# REGULATORY INFORMATION DISTRIBUTION SYSTEM (RIDS)

SUBJECT: FORWARDS AMEND TO APP A OF OL DPR-31 & DPR-41, DESCRIPTION OF PROPOSED CHANGES & REVISED TECH SPEC PAGES.

Re: Turkey Point Units 3 & 4  
Docket Nos. 50-250 & 50-251  
Proposed Amendment to  
Facility Operating Licenses DPR-31 & DPR-41

Re: Turkey Point Units 3 & 4  
Docket Nos. 50-250 & 50-251  
Proposed Tech Spec Change  
Appendix I

FIGURE 4.12-1  
TURKEY POINT  
RADIOLOGICAL ENVIRONMENTAL  
MONITORING SAMPLING POINTS

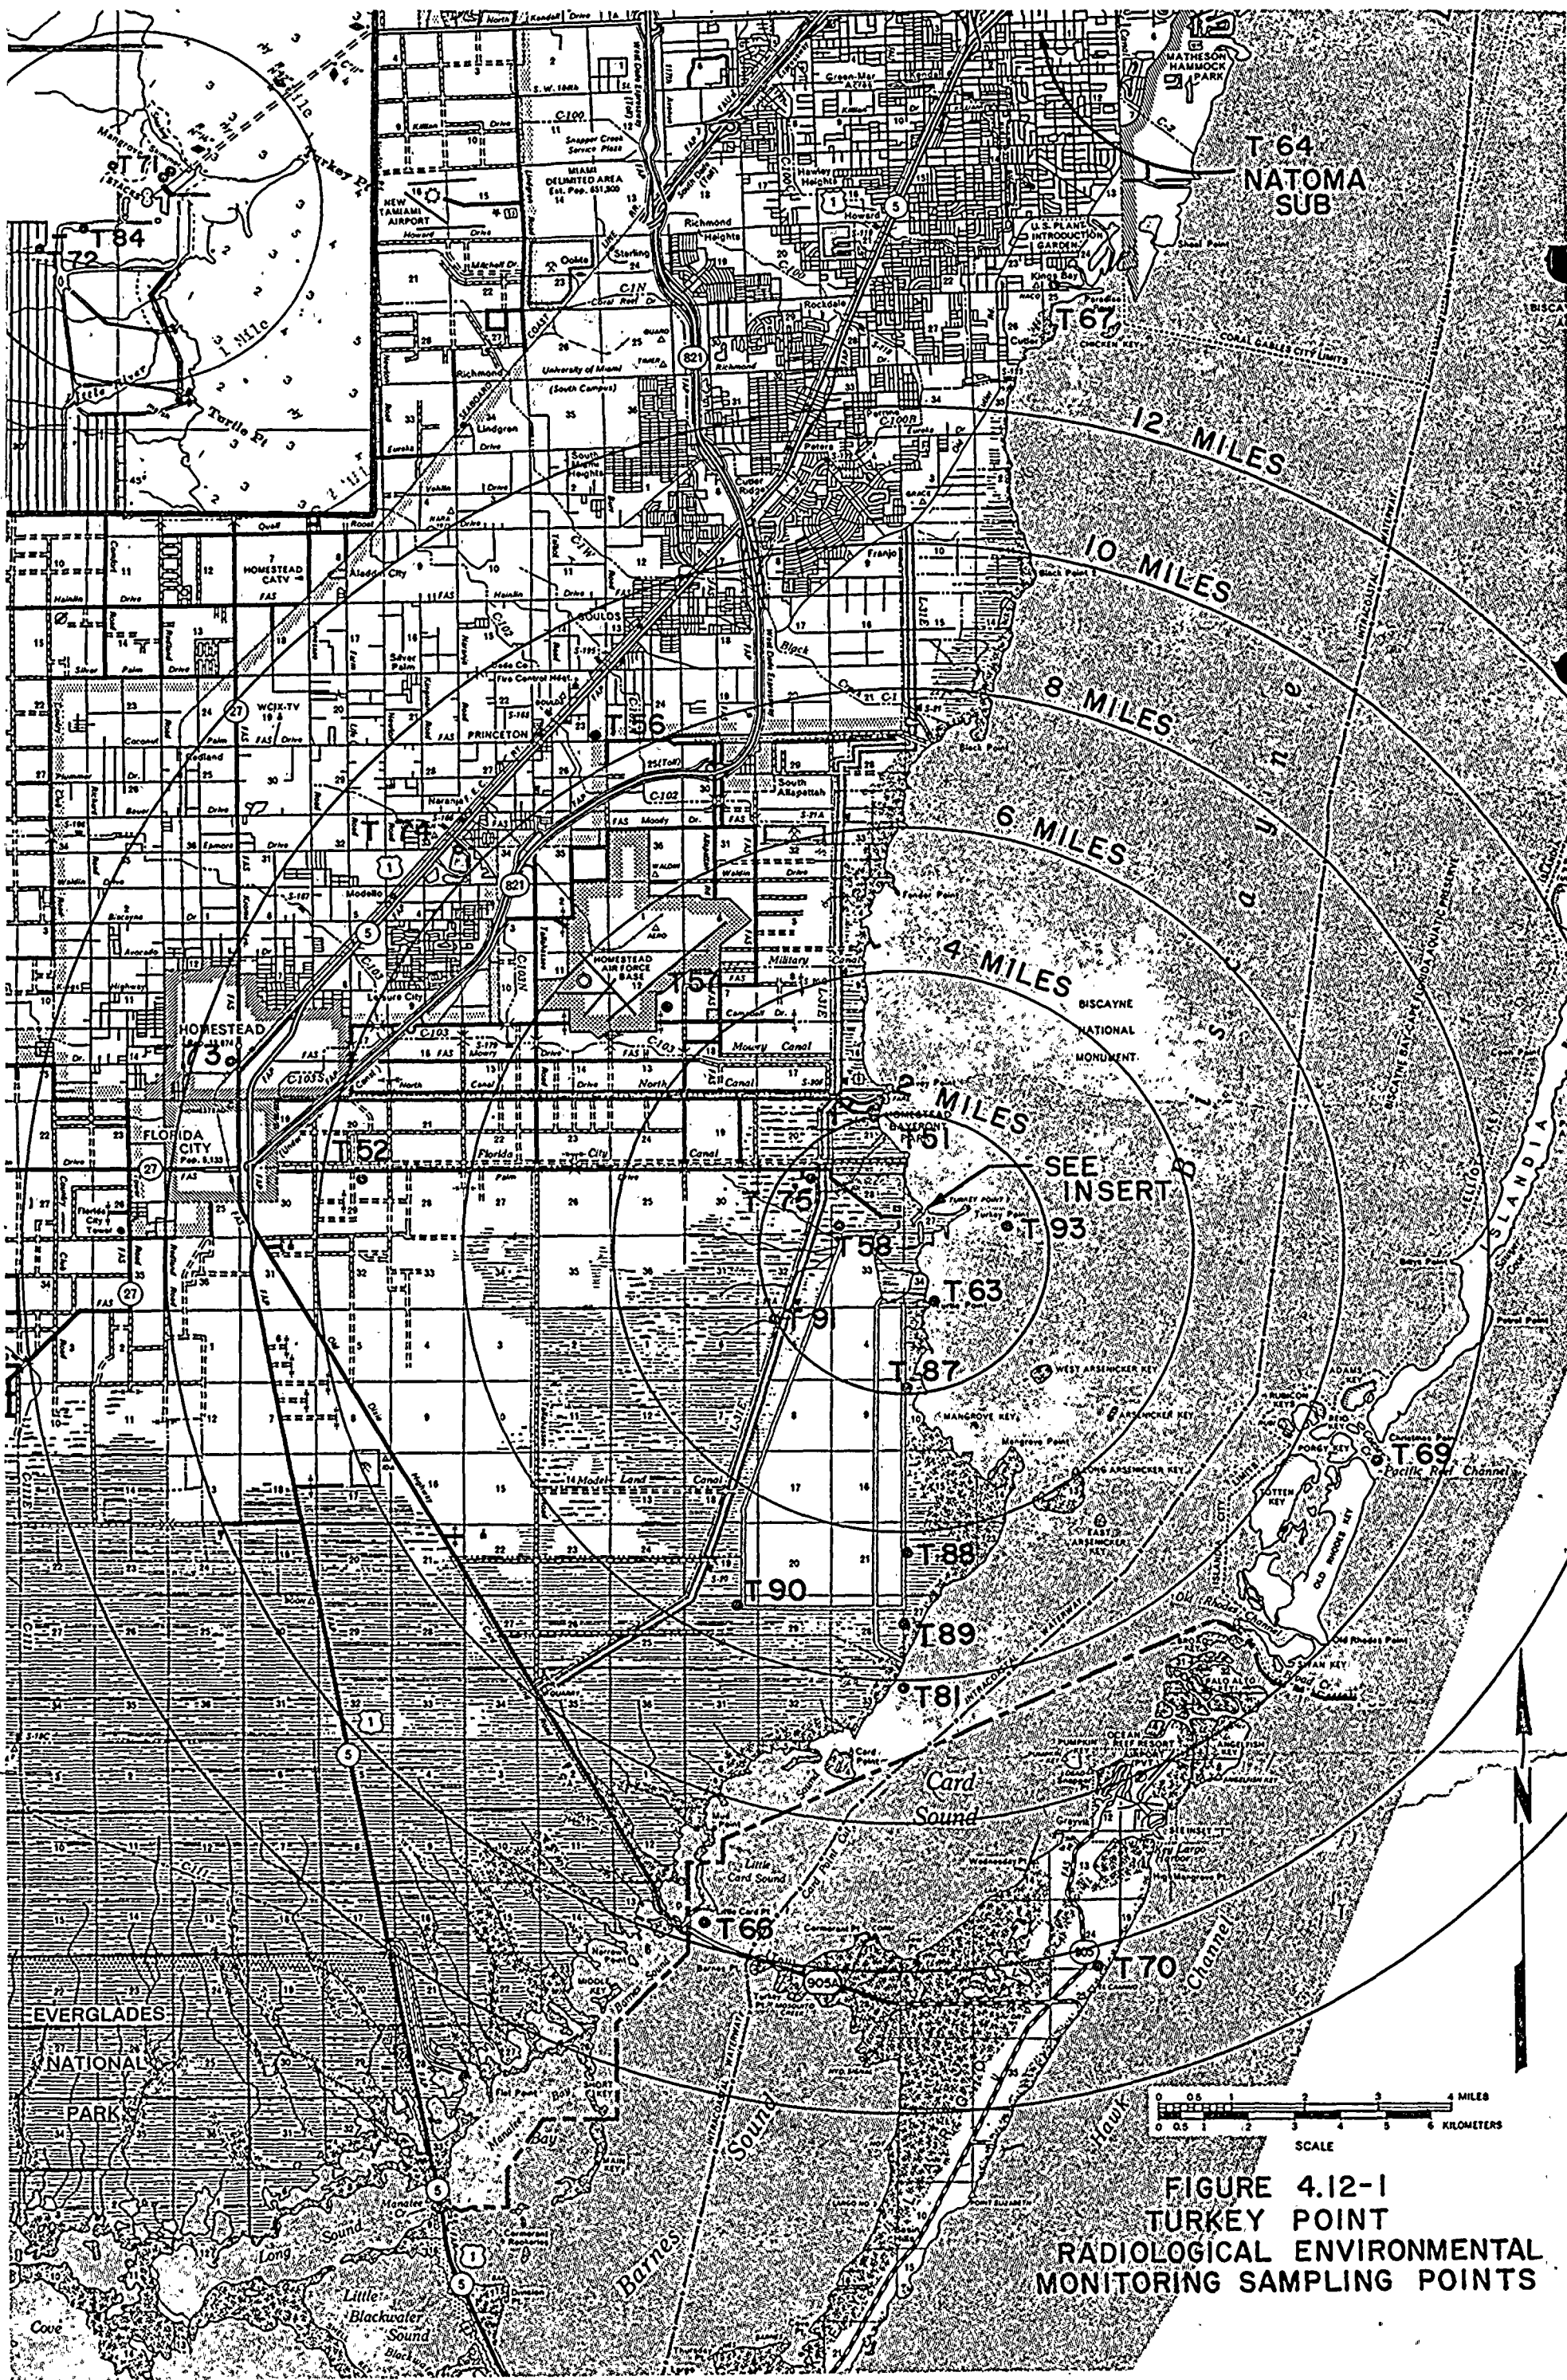
4.12-1 thru 4.12-3, Table 4.12-1 & 4.12-2, and Figure 4.12-1	Specification 4.12 on "Environmental Radiation Survey" is completely rewritten and retitled "Radiological Environmental Monitoring".

- Specification:
1. Environmental samples from the locations shown on Fig. 4.12-1 shall be collected and analyzed in accordance with Table 4.12-1. Maximum values for lower limits of detection shall be in accordance with Table 4.12-2.
